SUBJECT: BOARD NOTIFICATION - UPDATE ON MIDLAND STOP WORK STATUS
AND NRC STAFFING CHANGES

Review of Diesel Generator Building
at Midland Plant

REPLY TO R. B. LANDSMAN'S CONCERNS ON THE STRUCTURAL INTEGRITY OF THE
DIESEL GENERATOR BUILDING FOR MIDLAND NUCLEAR POWER PLANT

DIESEL GENERATOR BUILDING EXECUTIVE SUMMARY
SUMMARY OF ACTUAL AND ESTIMATED SETTLEMENTS
FIGURE ES-14

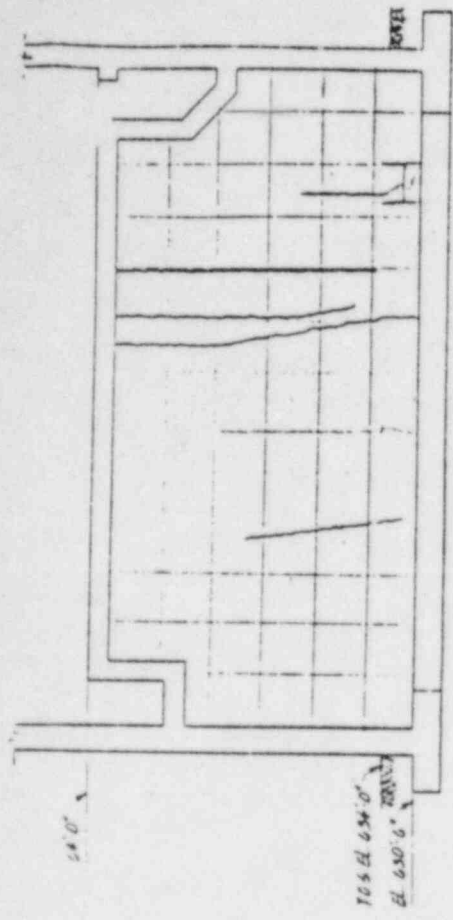
3. Inconsistencies in the documentation of the settlement history needs to be resolved. For example, the Midland Units 1 and 2 Executive Summary dated August, 1983 states that for the July 1978 period, the maximum settlements recorded were 3.5 inches while Figure ES-14 of the same document indicates a maximum of 1.99 inches for the same period.

Peak settlements anticipated at the end of 2025 (actual settlements to date plus secondary settlements from now till then) are specified in Ref. 7 to vary from 4.79 inches (under the NW corner) to 9.33 inches (under the SE corner). However, it should be mentioned that the exact settlement history at the various settlement markers at the DGB is open to question. For example, it is mentioned in Ref. 7 that the maximum settlements in August 1978 were about 3.5 inches. Yet the data used in the stress analyses for the presurcharge period (Figures ES-14 of Ref. 7) indicates peak settlements of only 1.99 inches. It was stated at one of the Bechtel presentations that prior to cutting the duct banks loose from the footing, footings along the North wall actually lifted off from the soil, with the DGB rotating about the duct banks. There is no indication of this behavior in any of the settlement data used in the computations. Ref. 8 lists the settlement increment from 8/79 to 12/2025 to be 2.36 inches under the SE corner of the building. For the same period Ref. 7 lists this data as 1.89 inches. Thus some inconsistencies appear to exist in the various documents.

DIESEL GENERATOR BUILDING EXECUTIVE SUMMARY
FINITE-ELEMENT MODEL
FIGURE ES-13

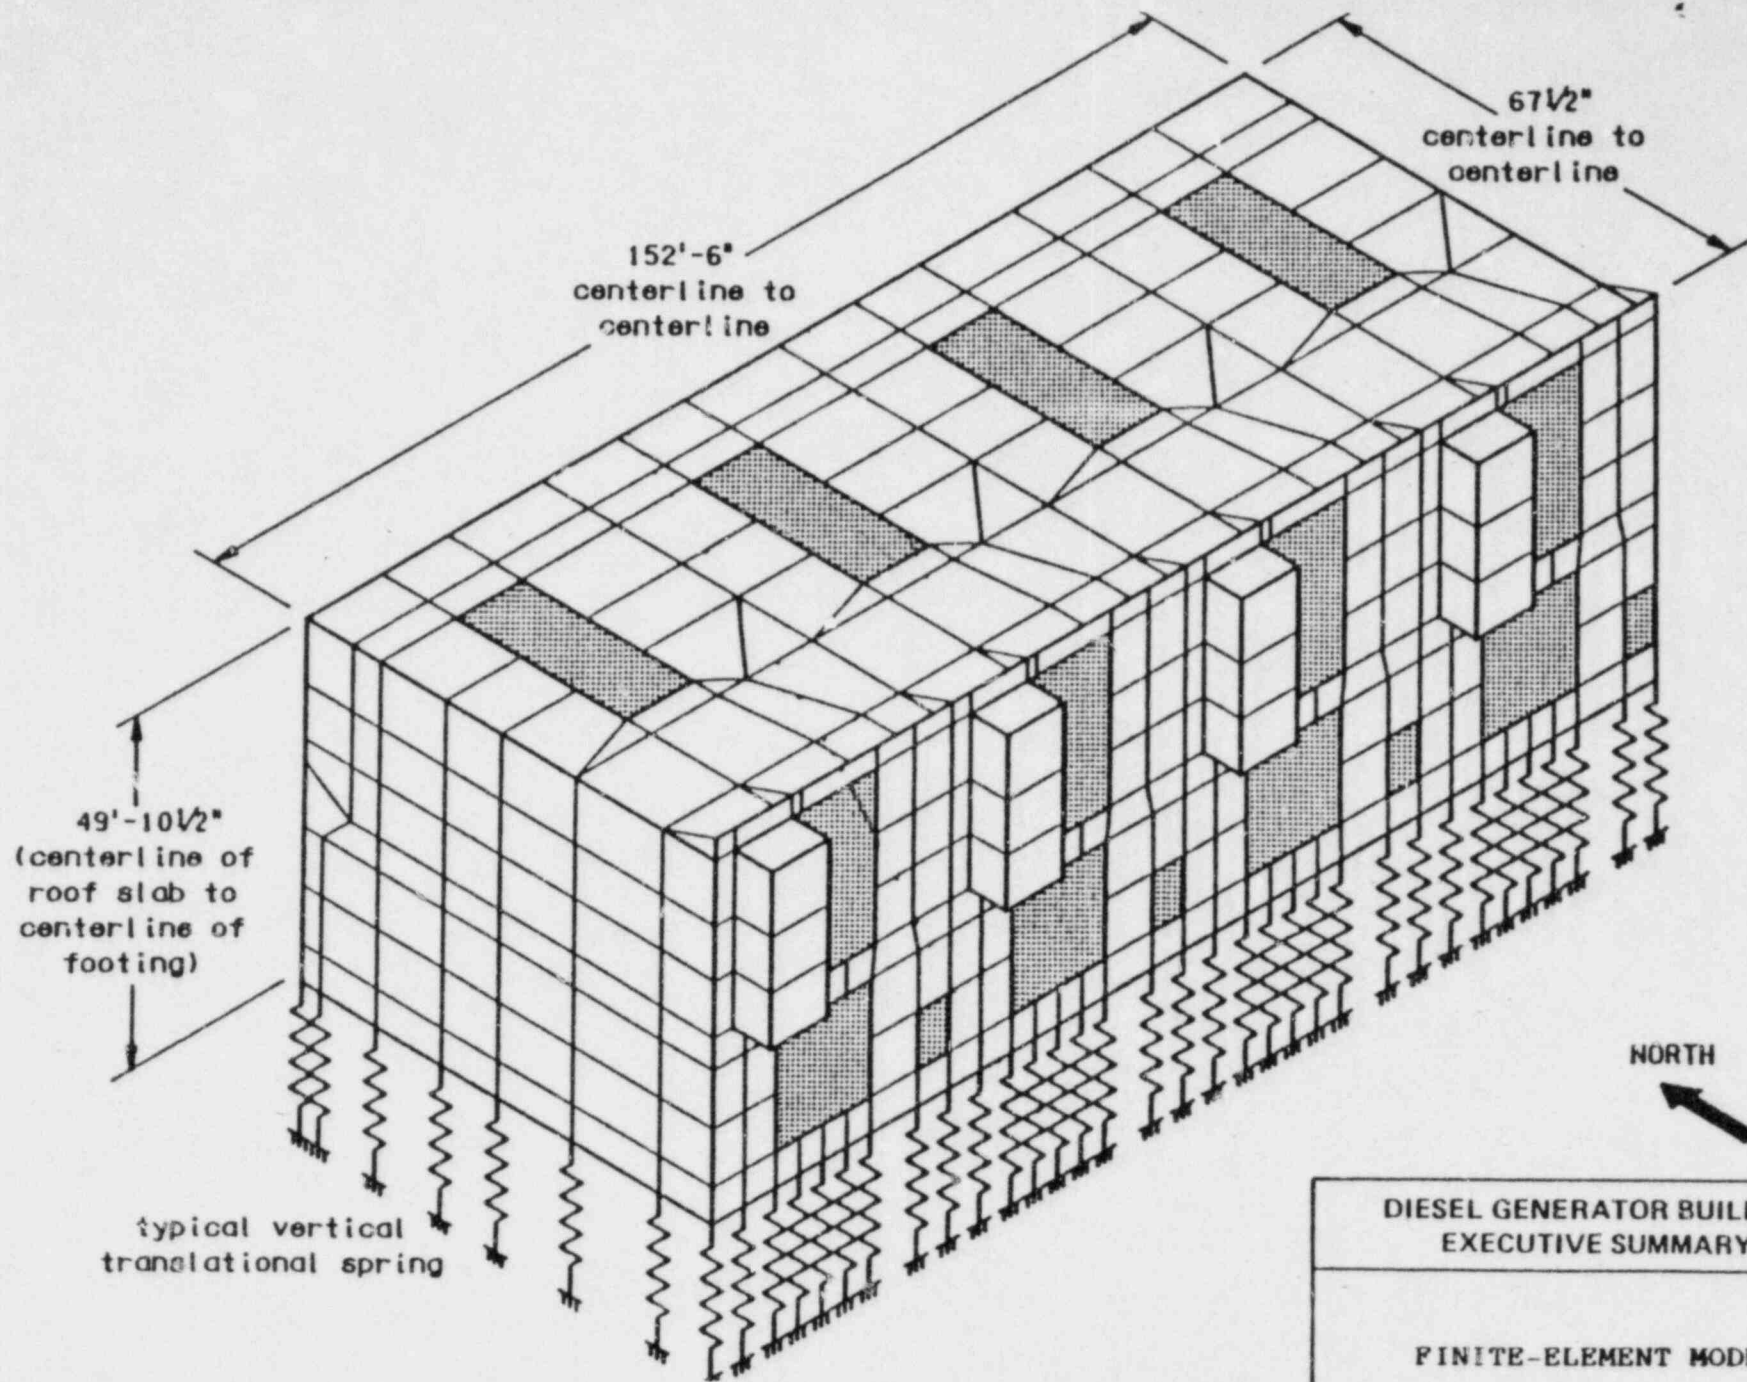
"My first concern deals with the finite element analysis that Consumers Power Company (CPCo) used to show that the building is structurally sound. Their model of the building assumed a very rigid structure without any cracks. The building has numerous cracks, reducing the rigidity of the structure. The effects of these cracks have not been taken into account in the analysis. CPCo's interpretation of the settlement data as a straight line approximation always stems from their position that the building is too rigid to deform as indicated by actual settlement readings. The settlement of the building occurred over a period of time during different phases of construction. It is this time dependent effect that was also not used in their model. Even CPCo expert Dr. Corely testified at the ASLB hearings that the analysis should have "taken into account cracking and time dependent effects" in order to give correct results. Finally, the staff's official position, as stated by Dr. Schauer, on CPCo's analysis was, "The staff takes no position with regard to that analysis."

The first part of this concern is that the cracks have not been considered in the Applicant's analyses. As indicated in previous discussion, cracks in the walls of the DGB are due to a combination of shrinkage, unequal settlement and temperature changes. Ordinary drying shrinkage and temperature change cracks are generally surface cracks. As soon as the cracks are formed, the tensile strain is relieved. Cracks due to differential settlement are generally through cracks across the wall thickness and, therefore, reduce the stiffness of the structural members. Structural engineers involved in reinforced concrete design are well aware of this fact. In order to take cracking
